Council Reference: DA15/0711 LN6502
Your Reference:

Development Application for additions and alterations to an existing dwelling to create an attached dual occupancy at Lot 337 DP 755740; No. 19 Queen Street FINGAL HEAD

Figure 1: Successful roof top deck (stepped into the top storey, consistent materials and partially roofed for useability)

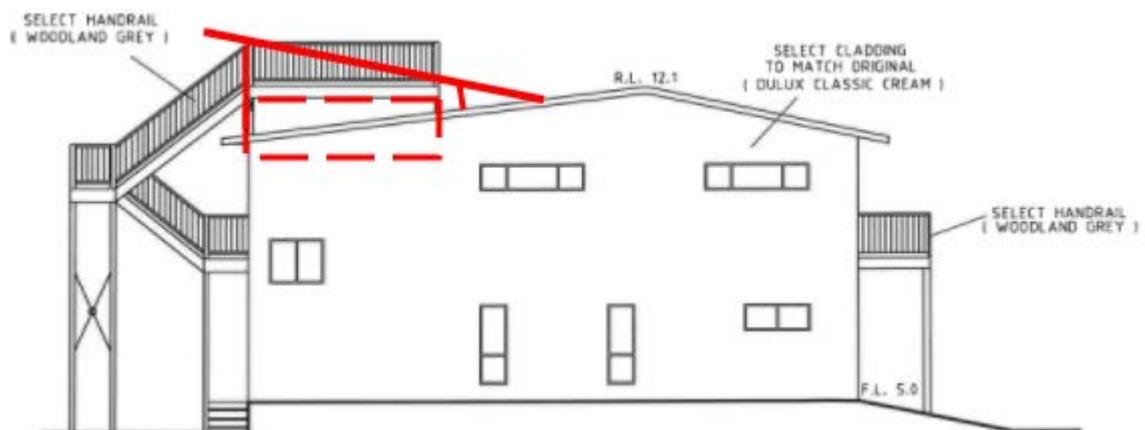
It is considered that there is opportunity for the roof deck proposed as part of the subject application to be integrated with the building in terms of roof line, materials and detailing and a reduction in size (the overall size of the roof deck is very large and could be significantly reduced). An overall reduction to one structural bay would also significantly reduce the visual impact of the proposed deck.

- *Design a complimentary roof over the deck so that the overall building form reads as a single identity.
This would require integrating the deck into the existing roof, to achieve compliance with the maximum building height map under clause 4.3 Height of Buildings of the Tweed Local Environmental Plan 2014; and*
- *Substantially reduce the proposed roof structure (or part roof structure) was complimentary to the main building.*

- There has been no reduction in the size of the proposed roof deck
- The deck has not been integrated into the existing building/roof line
- The introduction of cladding, whilst consistent with the colour scheme of the existing dwelling is considered to increase the bulk of the proposed deck
- The access stairs are not integrated into the building,
